**RE: PALOMAS BUSINESS PARK, TRACT X-1-A (D19-D24). ENGINEER'S  
CERTIFICATION FOR CERTIFICATE OF OCCUPANCY APPROVAL.  
ENGINEER'S STAMP DATED AUGUST 23, 1999.**

***RE: PALOMAS BUSINESS PARK, TRACT X-1-A (D19-D24). GRADING AND DRAINAGE PLAN FOR BUILDING PERMIT APPROVAL. Churchill Heights Assisted Living, TRACT X-1-B (D19-D22) STORM DRAIN PLAN. ENGINEER'S STAMP for latter DATED MARCH 1, 1999.***

***RE: Grading and Drainage Plan for Sandia Credit Union (D19/D24), Submitted for Building Permit Approval, Engineer's Stamp Dated 7/16/99.***

***RE: Grading and Drainage Plan for Sandia Credit Union (D19/D24), Submitted for Final Plat Approval, and Building Permit Approval, Engineer's Stamp Dated 7/16/99.***

**SANDIA CREDIT UNION SUPPLEMENTAL DRAWING  
ORIGINAL PLAN ENGINEER'S SEAL DATED 7-16-99**

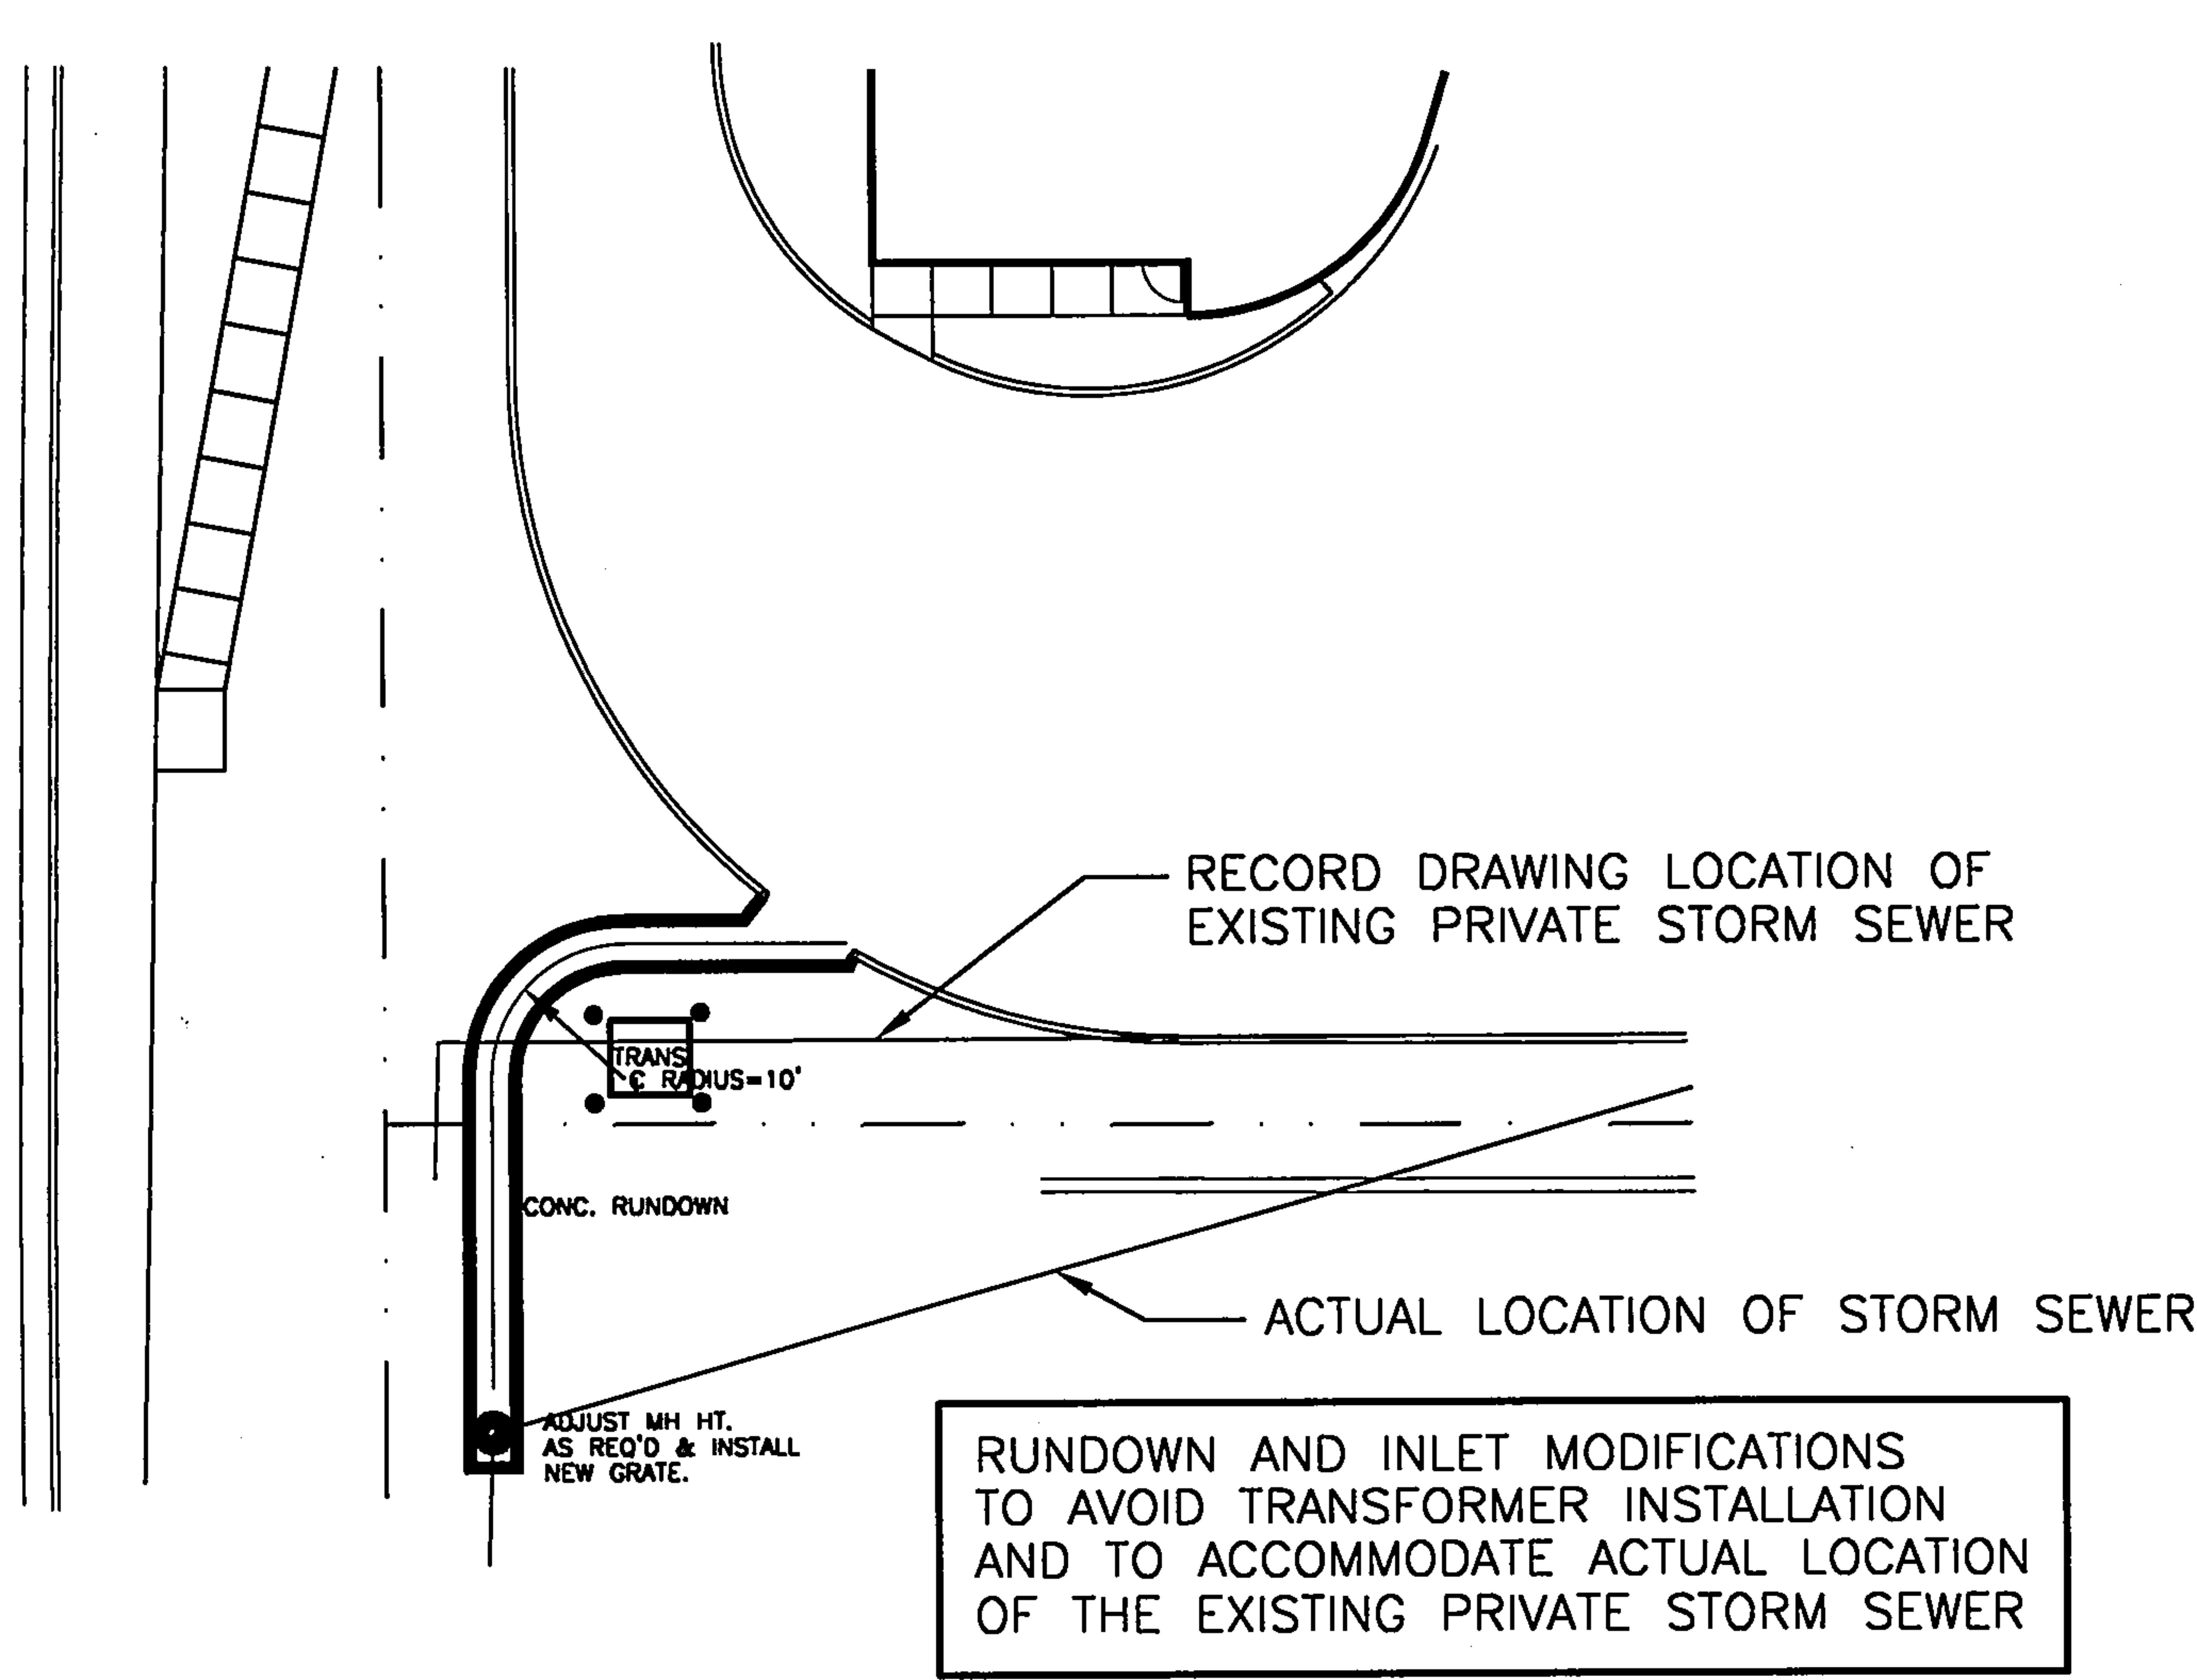
My previous letter of July 2, 1999 requested that additional comments be addressed on the plan prior to Building Permit approval. Although the supplemental information provided in the submittal of July 16, 1999 may have addressed my concerns about downstream capacity, the pertinent information must appear on your grading and drainage plan, since each plan must be able to stand alone.
